LANL TA-11 (NPDES)

MEMORANDUM

SUBJECT: DOE OB Observations Concerning NPDES Outfalls Scheduled for Deletion Through the Waste Stream Characterization Program at K-Site, TA-11, Los Alamos National Laboratory (LANL).

Fig. 5-49. Firing site.

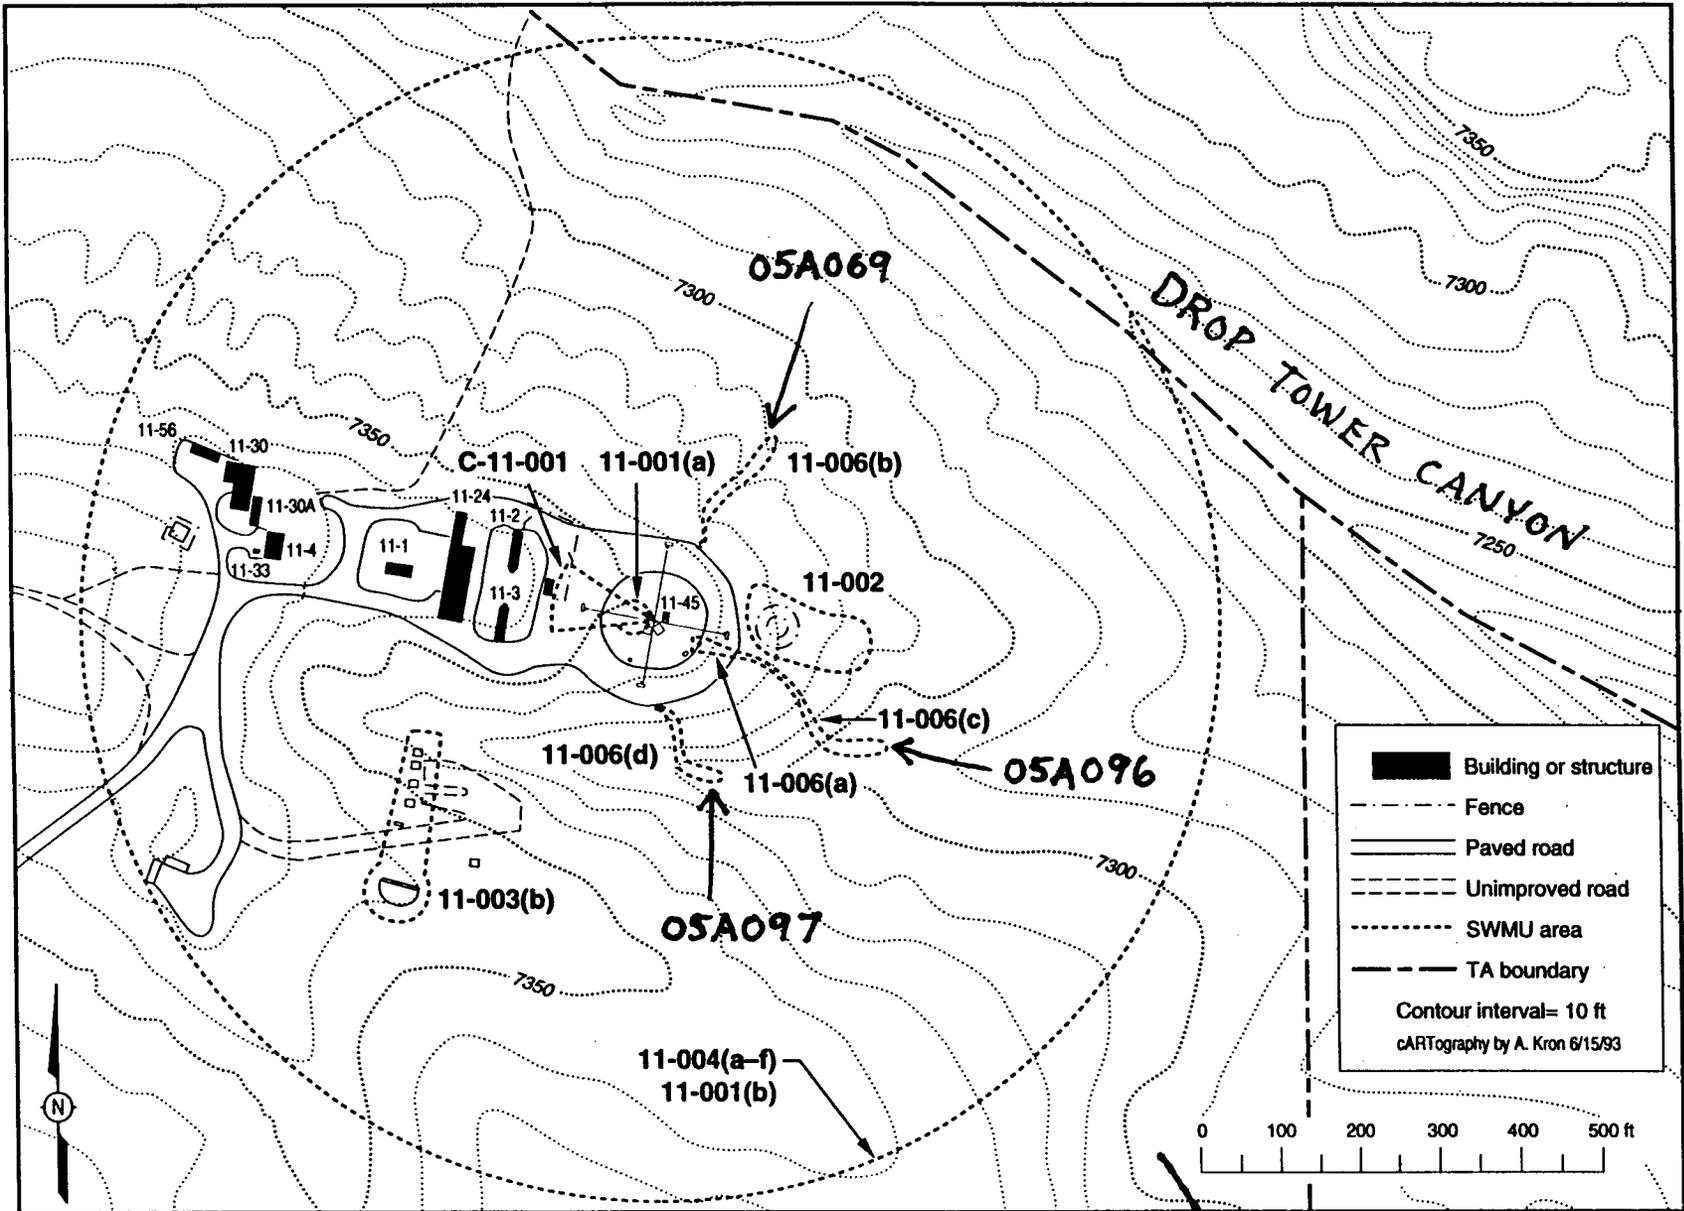
PROPOSED WORK DESCRIPTION: The proposed corrective action (CA) at K-Site is to consolidate the run-off paths of two (2) NPDES outfalls scheduled for deletion to one permitted outfall. It should be noted that all these outfalls are not pipes, but open concave asphalt ramps which direct water down the mesa edge to DropTower Canyon. In addition, the CA addresses only run-off water which is generated following a drop test due to washing down the pad with a high-pressure hose. Storm-water is not the focus of this CA, but it was recommended that it be addressed in the

Storm-water Pollution Prevention Plan under development for TA-11. The CA scheduled to close two of the three outfalls which drain the drop tower pad will require the in-place abandonment of sump TA-11-50, and the reconstruction of sump TA-11-51. Sump TA-11-51 will be fitted with a filtering system in addition to an above ground 12 inch pipe that will be connected to sump TA-11-52 which drains the southern perimeter of the Drop Tower pad. The outfalls, 05A069 & 05A096, associated with sumps TA-11-50 and TA-11-51 will be by-passed following the completion of the diversion pipe. The south-exiting outfall 05A097 will be up-graded, in addition to being engineered to mitigate any increased flow velocity and erosion potential that will arise due to the re-routing of the two by-passed outfalls. The asphalt berm at the perimeter of the drop tower pad will be repaired and elevated to a height of 12 inches. It is not known if this measure will address the sheet-flow storm-water issue at the site. Additionally, the outfalls proposed for deletion (05A069 & 05A096) will be left in-place and still route overflow storm-water to DropTower Canyon. Due to the likelihood that sump TA-11-50 is contaminated, it was recommended that, prior to abandonment, it be filled with some inert material in order that it does not collect and discharge any run-off or storm-water.

WORK NOT PROPOSED IN THE CA: A key issue not addressed by the CA is storm-water run-on to the drop tower pad from the west. One recommendation mentioned was that the asphalt berm located at the drop tower southern perimeter be extended west to compensate for the run-on. Another recommendation was to install a low-incline speed bump on the drop tower west entrance road to divert storm-water run-on. Other issues discussed included placement strategy of BMPs such as hay bales and jute mats to address the evident historic and current hillside erosion in order help check contamination in the soils and sediments on the mesa sides of the site. Because K-Site is listed as an active HE site, activities which might cause sparks, such as driving steel stakes or manual drilling/augering, are strictly controlled and/or forbidden. These restrictions might limit any future erosion efforts and BMP options by the LANL ER Project and ESH-18 Group.
